Please find attached submission raising objection to Development Application DA2022/1719
Lot 6 DP 8260 150 Queenscliff Road QUEENSCLIFF.

**Submission raising objection to Development Application DA2022/1719
Lot 6 DP 8260 150 Queenscliff Road QUEENSCLIFF**

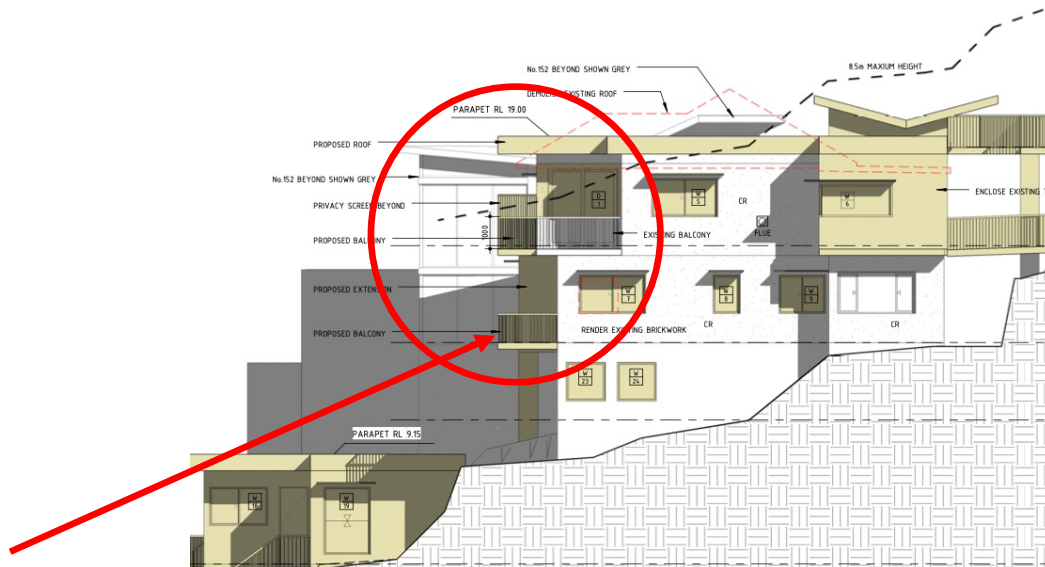
Furthermore, the SEE inaccurately states on page 16:

As the Development Application CAD diagrams themselves clearly disclose the existing principal dwelling will be extended beyond the existing footprint by 1.2 meters. This will result in adverse impact on the amenity of my property, loss of view and privacy.
